SIB 61 05 26

WASHER PUMP STRAINER LEAKING

2026-03-20

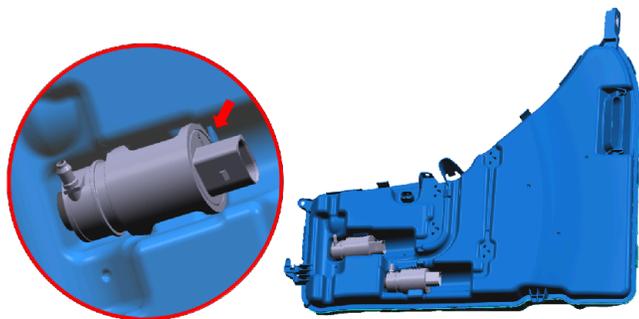
The top rubber ring on the washer pump's filter may be torn.

This can occur when the pump's filter is placed first on the washer fluid pump before being installed in the reservoir.

Replace the washer pump strainer(s) that are leaking with the updated part **(61 66 5 B83 629)**.

Note: P/N 61 66 5 B83 629 is to be used in place of the ETK/AIR P/N 61 66 5 A48 643.

4. First, install the updated (blue) pump strainer(s) into the windshield washer fluid reservoir. Next, insert the washer fluid pump into the rubber grommet.

5. After replacing the pump strainer(s), verify the pump's final position below the Z-rib (shown by arrow in the left portion of image).
